### 3. UPGRADE KIT FOR CHANGING TO NEW BEARING AND ADJUSTMENT BRACKET IN THE SHUTTLE FOR HM604 LOOMS

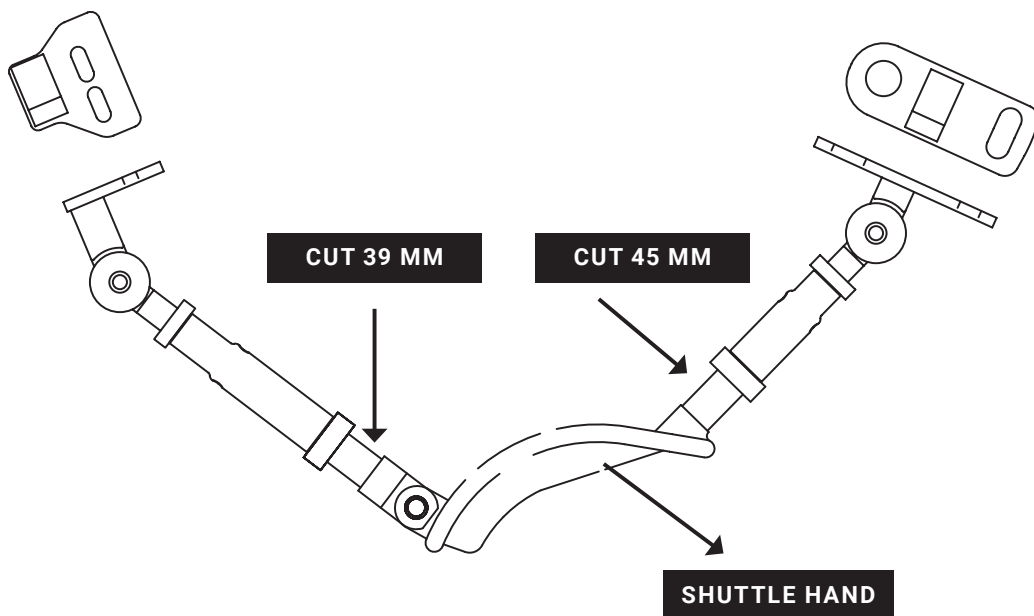
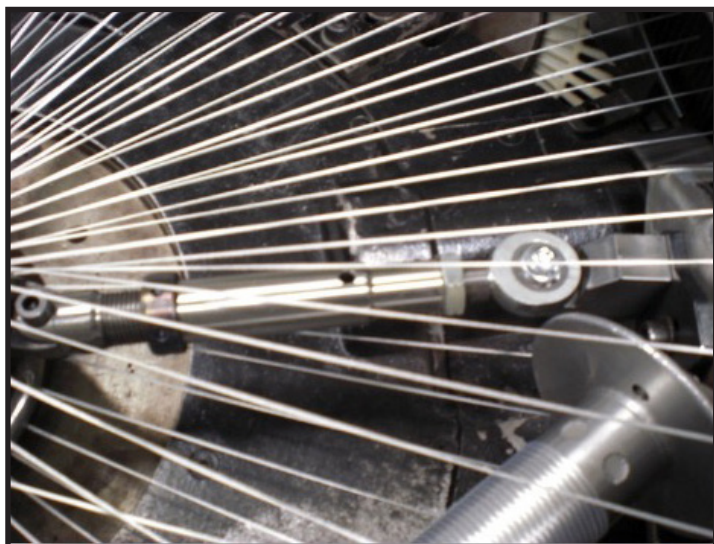
SHUTTLE HAND  
SCREWS MUST BE  
CUT TO FIT THE  
NEW ADJUSTMENT  
BRACKET FOR  
SHUTTLE HANDS
